**PLANNING COMMISSION STAFF REPORT
 MAY 17, 2018**

AGENDA ITEM 7.C File No. PL16-0054 – **TRINITAS MIXED USE PROJECT**

FIGURE 2: VIEW FROM SR 221 TOWARDS SOUTHWEST

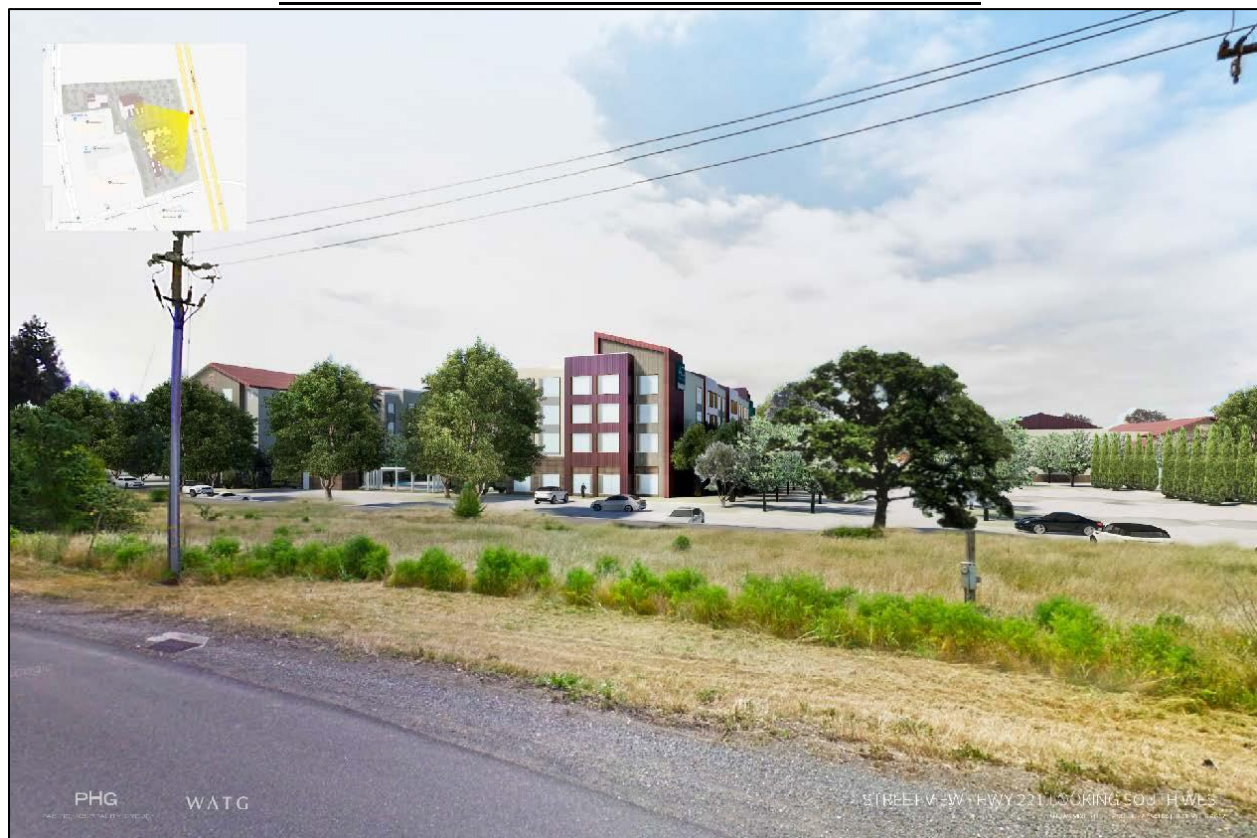
Site Grades: While the Trinitas site is largely level with little topography, it is important to be aware of the existing and proposed grade differentials between the site and surrounding streets, particularly SR 221. The Trinitas site lies below SR 221, with the grade difference becoming much more pronounced further north along SR 221. At the southeast corner of the site near the SR 221/Napa Valley Corporate Way intersection, the Trinitas site lies approximately 3 to 4 feet below the road surface of SR 221. This grade difference gradually increases, with the result that, at the northeast corner of the site near the adjacent Kaiser property, the Trinitas site is as much as 14 to 15 feet below the SR 221 road surface. This significant grade difference creates a challenge to introduce landscaping that will be sufficiently high so as to screen the majority of parked cars from the view of motorists traveling on SR 221. A low (two-foot to four-foot high) retaining wall is proposed running along the project's SR 221 frontage. This low retaining wall, which will not be visible from SR 221 because it is below the SR 221 travel way, will provide some screening of automobiles parking immediately adjacent to the wall, but not for cars located away from the wall.

The visual analysis in the DEIR (see in particular Exhibits 5.1-22, 23) provides a visual simulation of what the site will look like as viewed from SR 221 based on the landscaping proposed on the project plans. Based on these visual simulations, Staff determined that a sizable portion of the parking lot in front of the winery and the hotel will be visible from SR 221. This situation will be more problematic when the site is first developed because the visual simulations assume relatively mature parking lot trees. In order to address this issue, Staff is recommending the addition of landscaping within the 45 to 50 foot wide utility easement located between the project site and the SR 221 right of way. This added landscaping within the utility easement is discussed in the following section of this report under the heading "Landscaping /Screening".

While Staff is satisfied with the majority of the conceptual landscape plan provided, the exception is the need for additional landscape screening between SR 221 and the parking that parallels the highway. Approximately 40% of this parking frontage area is currently screened by existing vegetation located within the 50 foot wide landscape easement area that extends north along the project frontage from the SR 221/Napa Valley Corporate Drive intersection. However, as mentioned previously in this report, no new landscaping is proposed in the remaining 60% of the SR 221 frontage area. A condition has been added (see Conditions #12, #13) to address this situation by adding landscaping, including trees and shrub planting.
